**Figure PG-31**  
**Some Acceptable Types of Unstayed Flat Heads and Covers**

Item 22 - 2138

ASME BPVC.I-2021

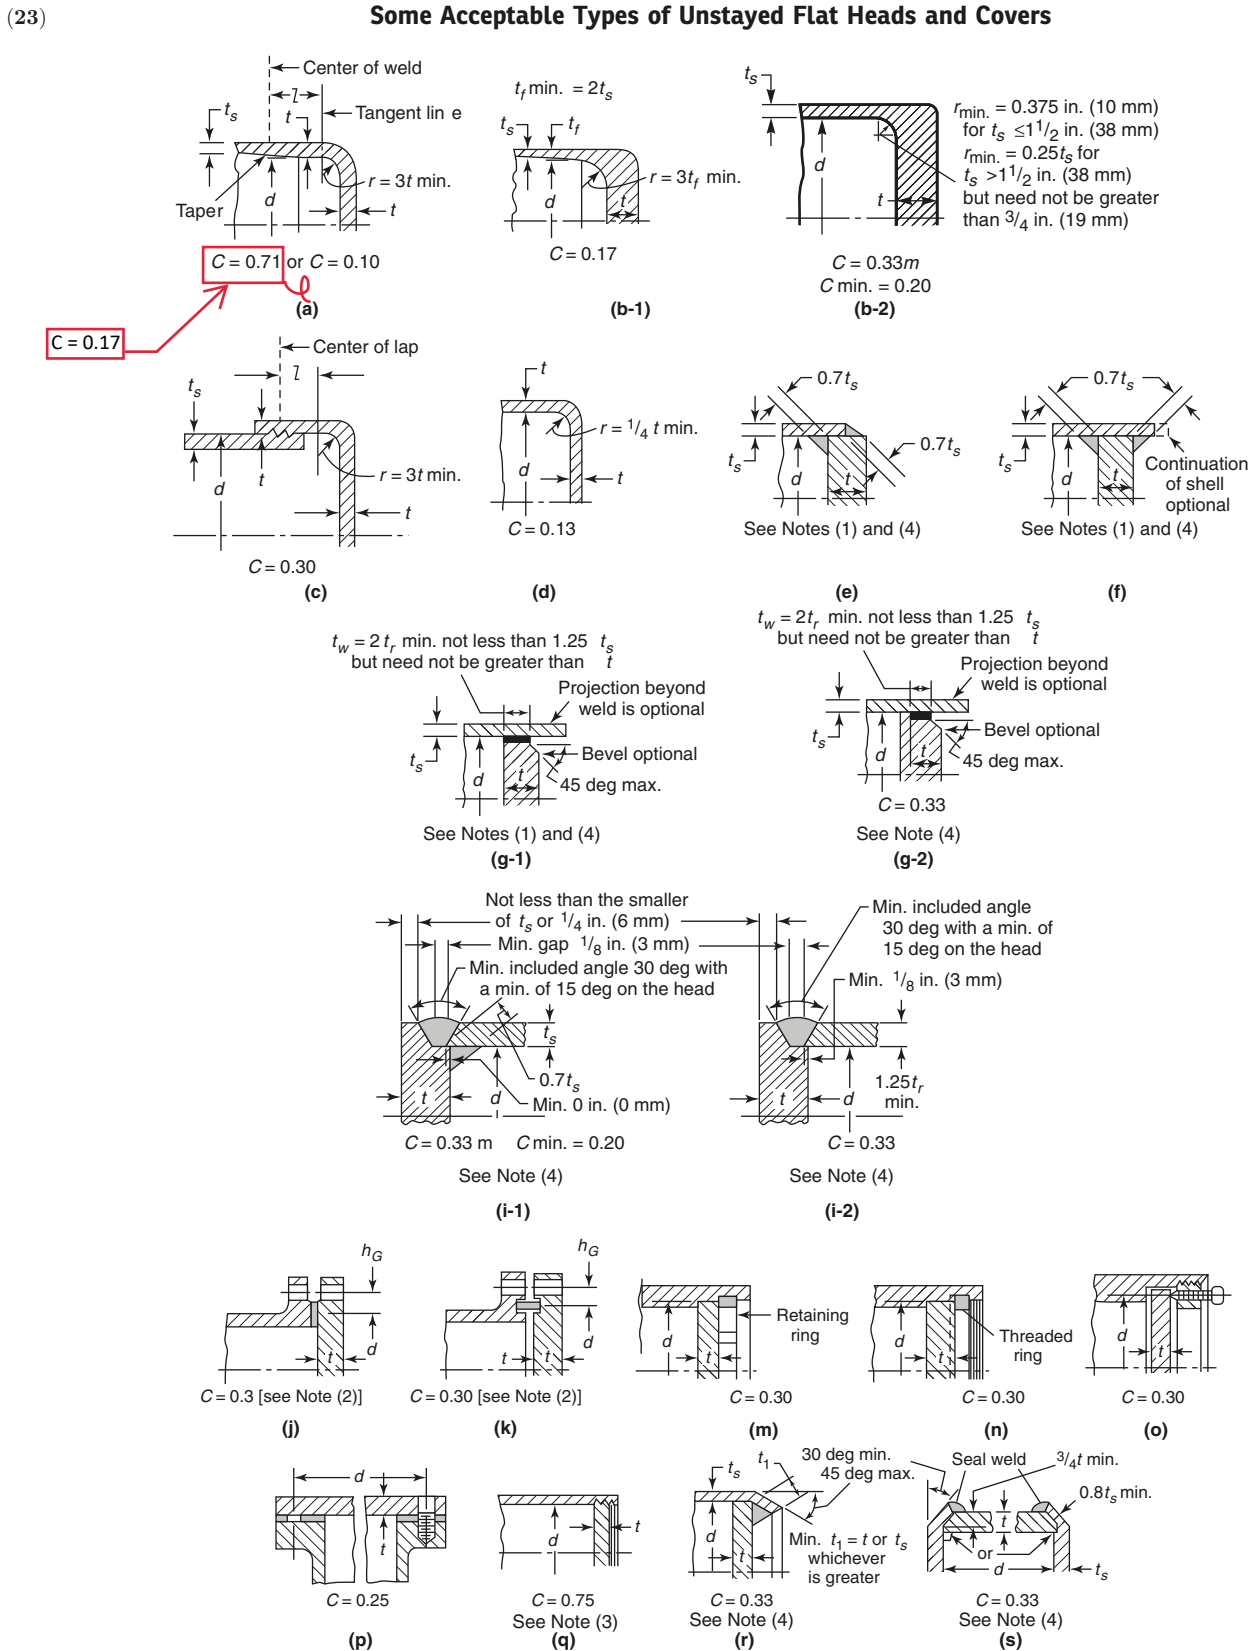
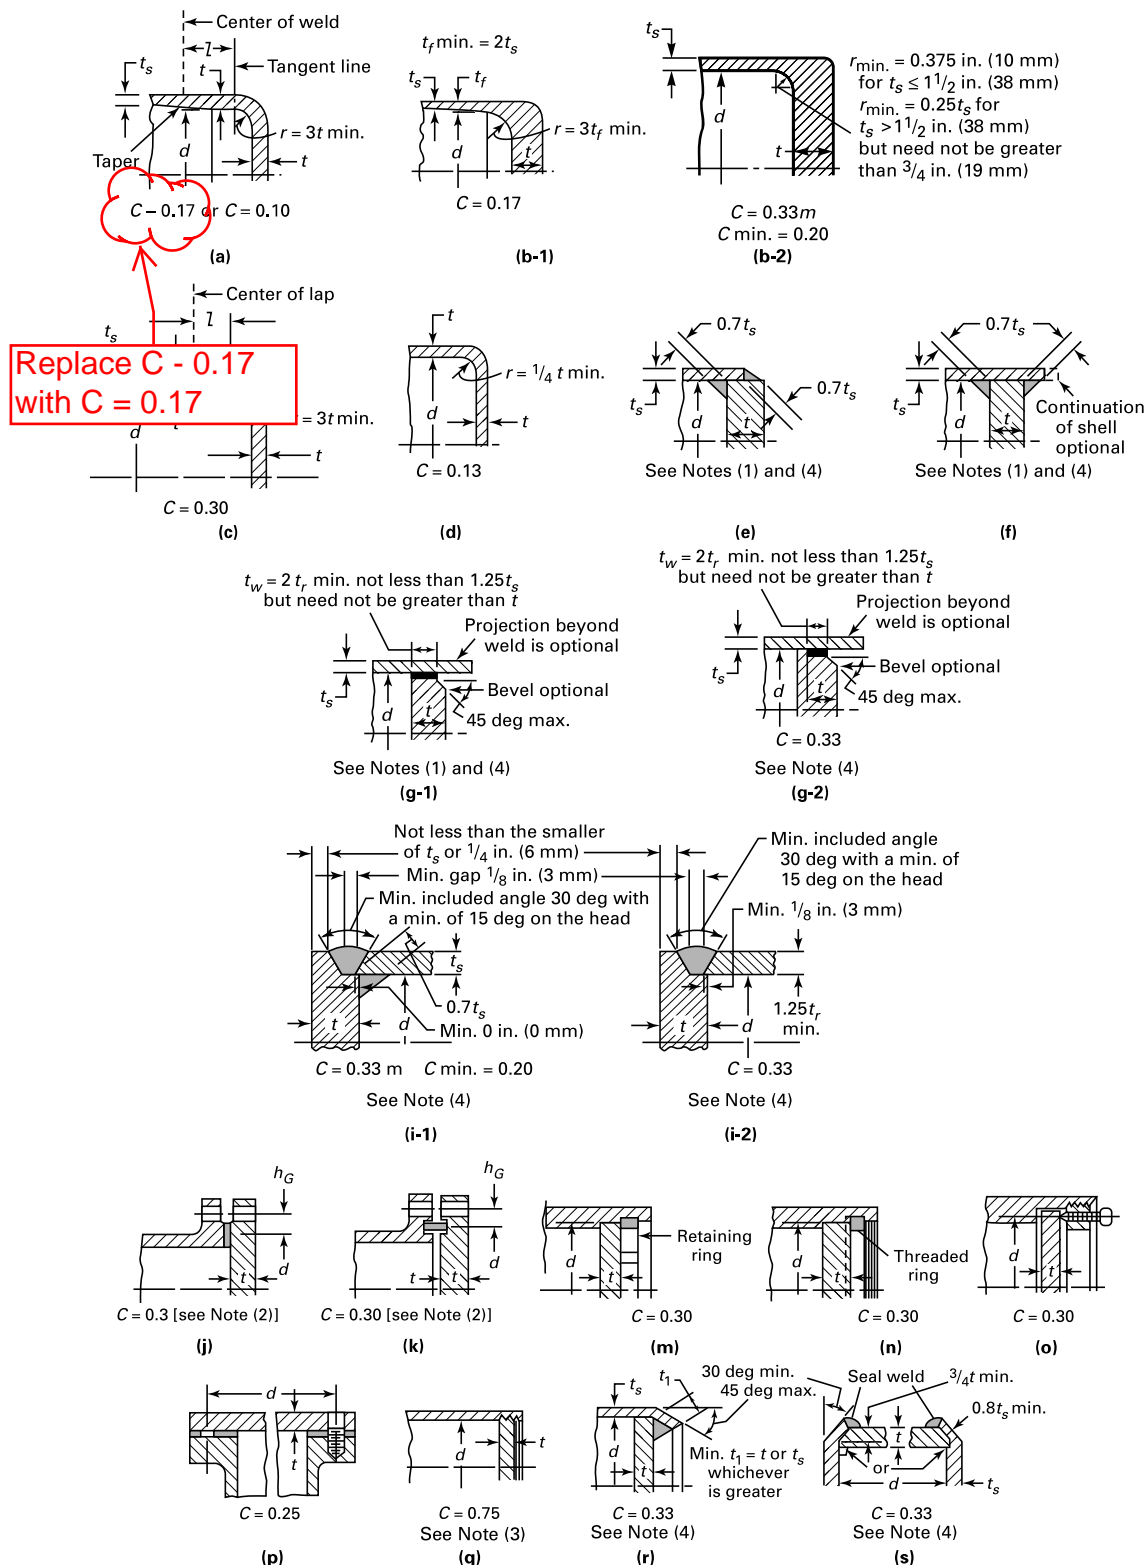
- (1) For illustrations (e), (f), and (g-1) circular covers,  $C = 0.33m$ ,  $C \text{ min.} = 0.20$ ; noncircular covers,  $C = 0.33$ .
- (2) Use PG-31.3.2 eq. (2) or PG-31.3.3 eq. (5).
- (3) When pipe threads are used, see Table PG-39.
- (4) Volumetric examination is not required for any of the weld joints shown in illustrations (e), (f), (g-1), (g-2), (i-1), (i-2), (r), and (s).

Figure PG-31, illustration (a):  $C = 0.17$  for flanged circular and noncircular heads forged integral with or butt welded to the shell, pipe, or header, with an inside corner radius not less than three times the required head thickness, with no special requirement with regard to length of flange, and where the welding meets all the requirements for circumferential joints given in Part PW. The forged head shall meet the requirements of PW-17.

$C = 0.10$  for circular heads, where the flange length for heads of the above design is not less than

When  $C = 0.10$  is used, the slope of the tapered sections shall be no greater than 1:3.

Figure PG-31, illustration (b-1):  $C = 0.17$  for circular and noncircular heads forged integral with or butt welded to the shell, pipe, or header, where the corner radius on the inside is not less than three times the thickness of the flange and where the welding meets all the requirements for circumferential joints given in Part PW. The forged head shall meet the requirements of PW-17.

Figure PG-31, illustration (b-2):  $C = 0.33m$  but not less than 0.20 for forged circular and noncircular heads integral with or butt welded to the shell, pipe, or header, where the hubbed flange thickness is not less than the shell thickness, and the corner radius on the inside is not less than the following:

Figure PG-31, illustration (c):  $C = 0.30$  for circular flanged plates screwed over the end of the shell, pipe, or header, with inside corner radius not less than  $3t$ , in which the design of the threaded joint against failure by shear, tension, or compression, resulting from the end force due to pressure, is based on a factor of safety of at least 4, and the threaded parts are at least as strong as the threads for standard piping of the same diameter. Seal welding may be used, if desired.

Figure PG-31, illustration (d):  $C = 0.13$  for integral flat circular heads when the dimension  $d$  does not exceed 24 in. (600 mm); the ratio of thickness of the head to the dimension  $d$  is not less than 0.05 nor greater than 0.25; the head thickness  $t_h$  is not less than the shell thickness  $t_s$ , the inside corner radius is not less than  $0.25t$ ; and the construction is obtained by special techniques of upsetting and spinning the end of the shell, pipe, or header, such as are employed in closing header ends.
